**HISTORIC PRESERVATION REVIEW BOARD
STAFF REPORT AND RECOMMENDATION**

Property Address:	1421 Corcoran Street, NW	X	Agenda
Landmark/District:	14th Street Historic District		Consent Calendar
Meeting Date:	February 26/March 5, 2015	X	Concept Review
H.P.A. Number:	15-139		Alteration
Staff Reviewer:	Steve Callcott	X	New Construction
			Demolition
			Subdivision

Architect Gregory Rubbo, representing owner Bashir Halabi, seeks conceptual design review for construction of a three-story row house in the 14th Street Historic District.

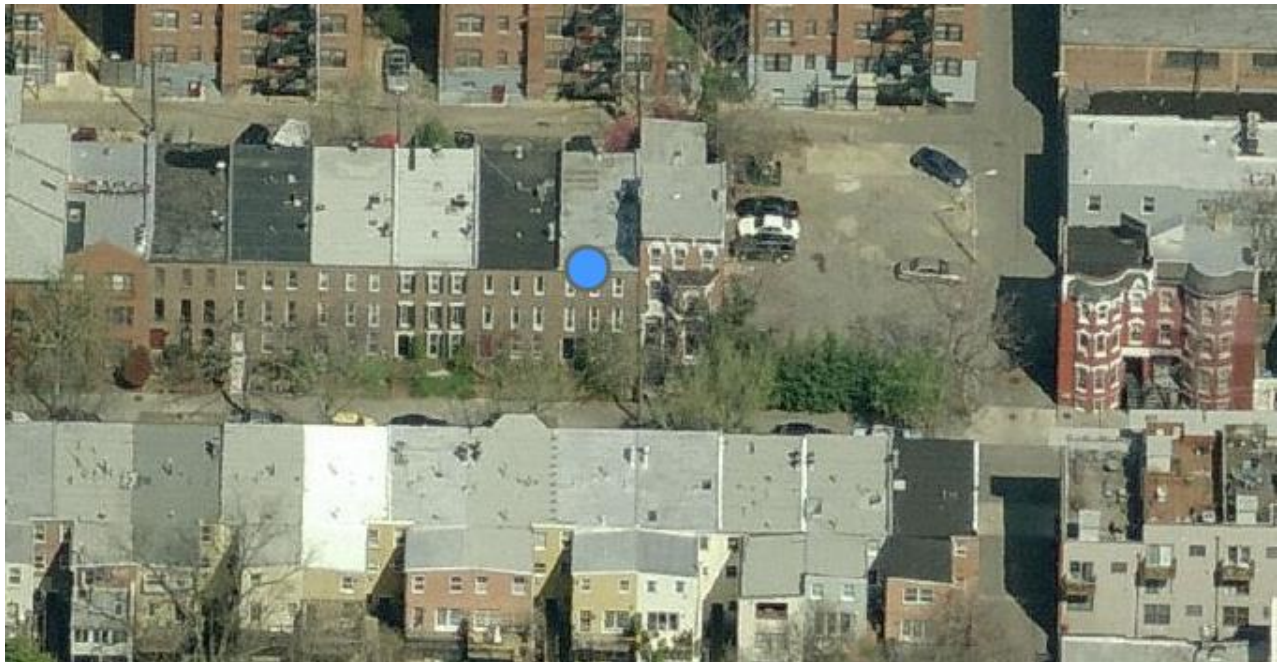
Despite the setback from the front façade, the proposed fourth floor level would be seen in perspective above the shorter houses to the west, raising concerns about the compatibility of the building's massing and form. In its review of the new construction at 1431 Corcoran, the Board found a similar visible partial fourth floor to be unprecedented on this block, and not consistent with the character of rooflines and rowhouse massing in the historic district. The Board approved the proposal at 1431 Corcoran contingent on the elimination of the fourth floor.

The organization and orientation of the basement stairs is not typical for the historic district (where the stairs run parallel to the primary stairs) and results in an areaway that is proportionally large to the small front yard. It may be worth studying whether slightly raising the building (thus reducing the number of steps down to the basement) and/or some alternative organization could minimize the extent that the areaway projects and whether more green space could be gained.

- *the three-story height, façade alignment, and conceptual façade composition are compatible with the character of the historic district;*
- *the partial fourth-floor should be eliminated or designed so as to not be visible from perspective views from the street;*
- *the basement stair and areaway should be studied to retain the maximum amount of front yard green space;*
- *the project should return to the Board with further information on materials and detailing.*
